RE: The Exchange Lot 1  
Project number: SP23-080

Please find below our responses addressing the Town's 2<sup>nd</sup> Submittal Review comments for the proposed project located at 19590 Mainstreet, Parker, CO 80138.

The Exchange Lot 01  
2<sup>nd</sup> Submittal Review Comment Responses  
02/02/2024

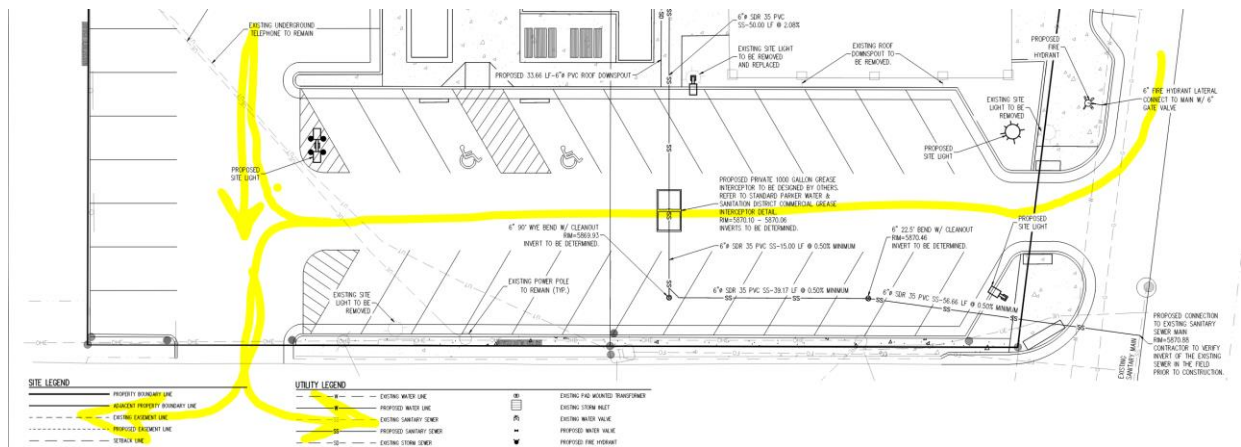
2. The applicant shall provide a room layout (in advance of a plan set for the commercial building permit) so as to ensure that the riser room is sized appropriately. With regard to the fire sprinkler control valve room, ensure that the following is addressed:

- Exterior access is required into the riser room with access into the building provided either adjacent to the riser room or through the riser room.

- The FACP will be required to be located on an interior wall in the fire sprinkler control valve room; ensure that the riser room is sized to accommodate the FACP and the riser. A three-foot clearance is required in front of the FACP as well as the sprinkler riser.

- The underground shall enter the building and turn up no further than 24 inches from foundation wall; three feet of clearance is required in front of the fire riser with a minimum of 12" of clearance behind the riser and 18" to each side of the riser.

- The FDC location requires three feet of clear space on either side of the FDC... just as a fire hydrant requires the same clear spaces.

**Note – This is a requirement that is not allowed to be deferred until the building submittal has been made. Exterior door access, riser room location, water entry, etc. all must be confirmed prior to site plan approval. Please work with your design team to ensure that the required information is provided. The site plan will not be approved without the required information.**

**Response: Fire riser room has been added to the utility plan**
